**Request for Additional Information No. 17 Supplement 1, Revision 0**

**U.S. EPR Standard Design Certification**

**SRP Section: 15.00.03 - Design Basis Accidents Radiological Consequence**

**Application Section: FSAR 11.1 and 15.0.3**

**Figure 15.00.03-24-1—Normalized Iodine Aerosol Release Airborne**

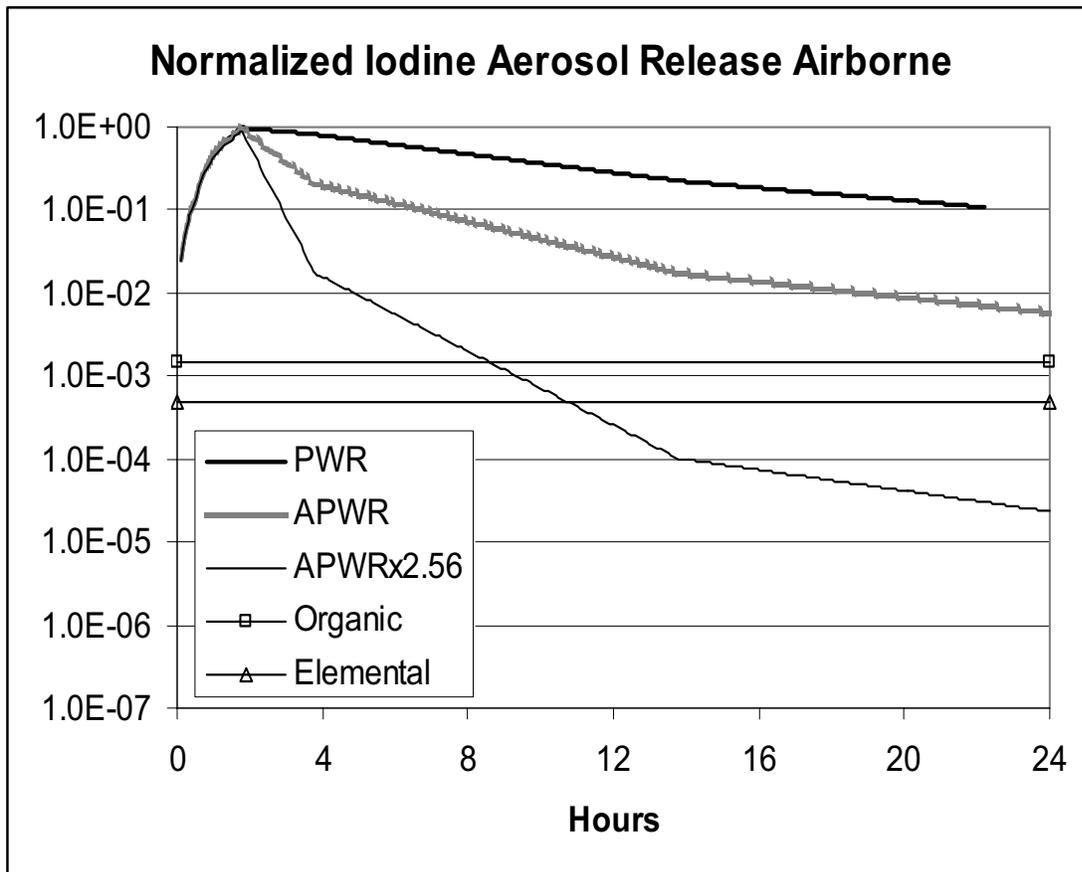
In the LOCA and REA dose analyses, the Powers natural deposition model and the “Henry model” for aerosol removal in containment were combined to model aerosol deposition in the containment. The Henry model has not previously been reviewed or found acceptable for use in reactor licensing. Please justify the use of the Henry model for aerosol natural deposition in the EPR containment.

Figure 15.00.03-24-1—Normalized Iodine Aerosol Release Airborne presents the normalized aerosol airborne activity for the U.S. EPR with and without phoretic deposition, at 4612 MWt as represented by the APWRx2.56 (4612/1800) line, based on the methodology described in Section 2.2.2.1 of NUREG/CR-6604.

The sedimentation-only rates of the 10<sup>th</sup> percentile Powers PWR correlation (as implemented in RADTRAD) are much lower than either the RADTRAD-implemented 10<sup>th</sup> percentile Powers BWR or APWR correlation values, so therefore the time frame over which the Powers PWR correlation has been defined should be much longer than 22.2 hours. The PWR sedimentation rates are conservative (if not overly conservative by virtue of having been established at the 10<sup>th</sup> percentile and the fact that they basically ignore phoretic deposition), but what substantially limits the usefulness of the correlation is the cessation of removal at 22.2 hours. It is this fundamental limitation of the Powers correlation that the time extension using the RADTRAD Henry model is intended to remedy.

Figure 15.00.03-25-1—Relationship of PWR Power to Containment Volume

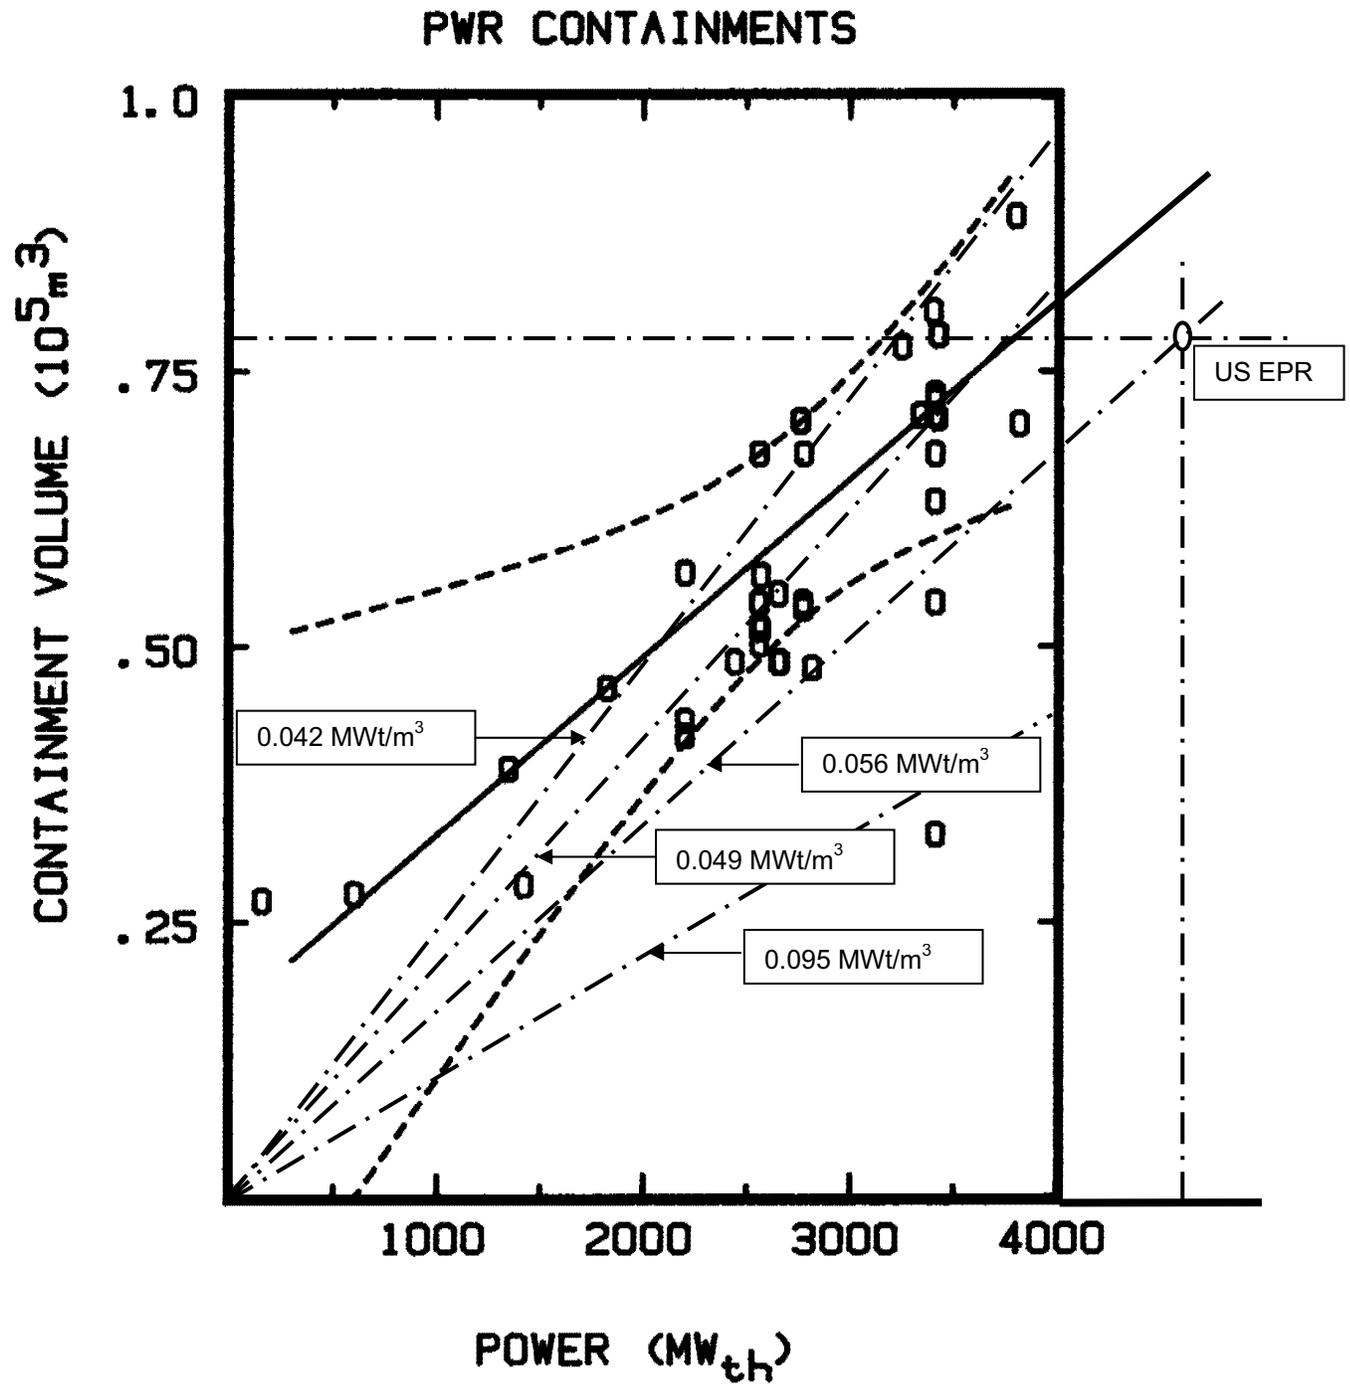
In the LOCA and REA dose analyses, aerosol deposition in containment is modeled in part by using the 10<sup>th</sup> percentile Powers natural deposition correlation in RADTRAD. Considering that the Powers natural deposition correlation was developed using operating pressurized water reactor (PWR) and boiling water reactor (BWR) information on containment geometry and power, justify the applicability of the Powers natural deposition correlation to the EPR containment.

Figure 15.00.03-25-1— Relationship of PWR Power to Containment Volume is a markup of Figure 18 in NUREG/CR-6189, “A Simplified Model of Aerosol Removal by Natural Processes in Reactor Containments,” the supporting document for the Powers natural removal correlations found in NUREG/CR-6604, “RADTRAD: A Simplified Model for RADionuclide Transport and Removal And Dose Estimation.”

The original NUREG/CR-6189 Figure 18 shows the data considered in establishing the functional relationship between containment volume and the reactor power level. Figure 18 considers reactor power as high as 4000 MWt. The solid line is the correlation line for the 32 data points considered. It has the formula  $V(m^3) = 16700(\pm 5500) + 16.16(\pm 1.94) \bullet P(MWt)$ , where V is the volume and P is the power level, and has been extended beyond 4000 MWt to include the power level of the U.S. EPR.

The actual volume of the U.S. EPR containment ( $7.9E4 m^3$ ) is within the stated uncertainty ( $1.4E4 m^3$ ) when compared to the central estimate of the volume according to the formula ( $9.1E4 m^3$ ). It is near the favorable limit of the uncertainty; i.e., the smaller the containment volume, the higher the mass concentration and the greater the sedimentation rate. The volume of the U.S. EPR is near the most favorable (smallest) end of range of PWR containment volumes (per unit reactor power) considered statistically possible with respect to the development of the Powers correlations. Even the median sedimentation rate based on a statistical treatment of the reactor power/containment volume relationship described by the formula above is conservative for the U.S. EPR.

Figure 15.00.03-25-1 shows plots of the three NUREG-1150 reactor power per unit containment volume values and the value for the U.S. EPR. For small power levels there are significant deviations; however, at reactor power levels above 1000 MWt, three of the four plotted slopes describe the range of the data reasonably well with Zion providing the upper bound of containment volume for a given reactor power level, Surry providing the central estimate, and the U.S. EPR providing the lower bound. The statistical outlier is Sequoyah, which is understandable given its ice condenser containment design.

**Figure 15.00.03-30-2—Fractional Core Release Rate for Iodine to IRWST**

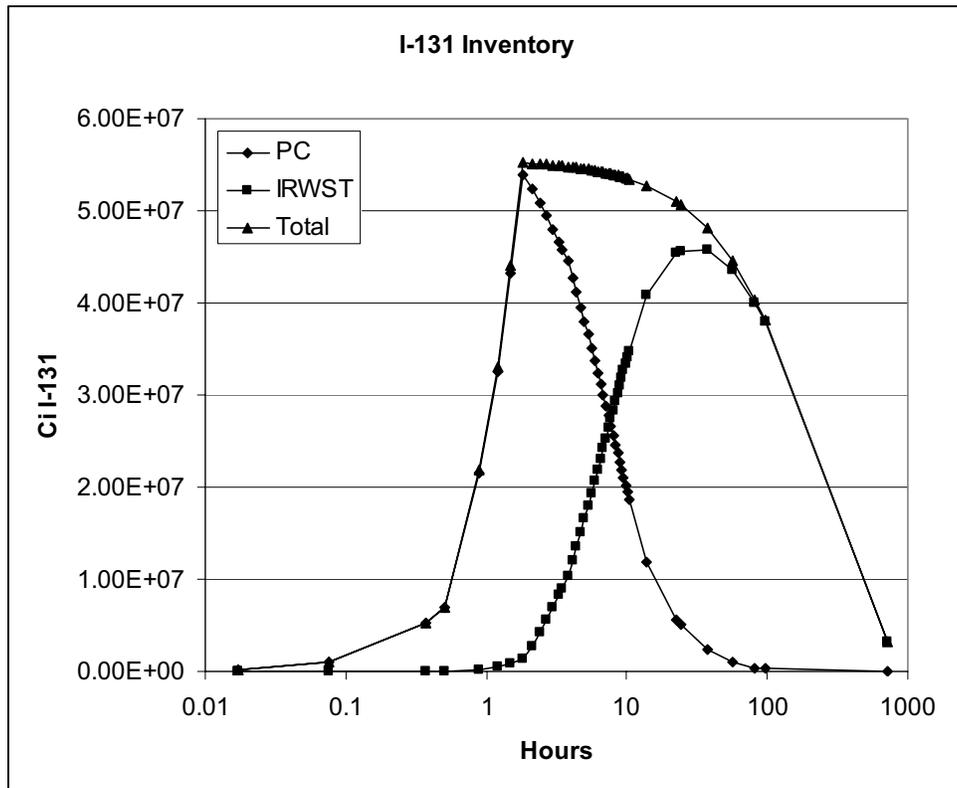
In regard to the LOCA engineered safeguard features (ESF) component leakage dose analysis, provide the ESF component leakage source term and the basis for the assumed values.

The fractional iodine release rates from the core directly to the IRWST that will mimic removal from the primary containment atmosphere (due to natural deposition) are shown in Figure 15.00.03-30-2—Fractional Core Release Rate for Iodine to IRWST and tabulated in Table 15.00.03-30-1.

The area under the curve in Figure 15.00.03-30-2 is 0.4, representing 40 percent of the total iodine release. As presented in Figure 15.00.03-30-2, most of the iodine enters the IRWST from 1.5 to ten hours. These rates assume that decay in the core is accounted for separately.
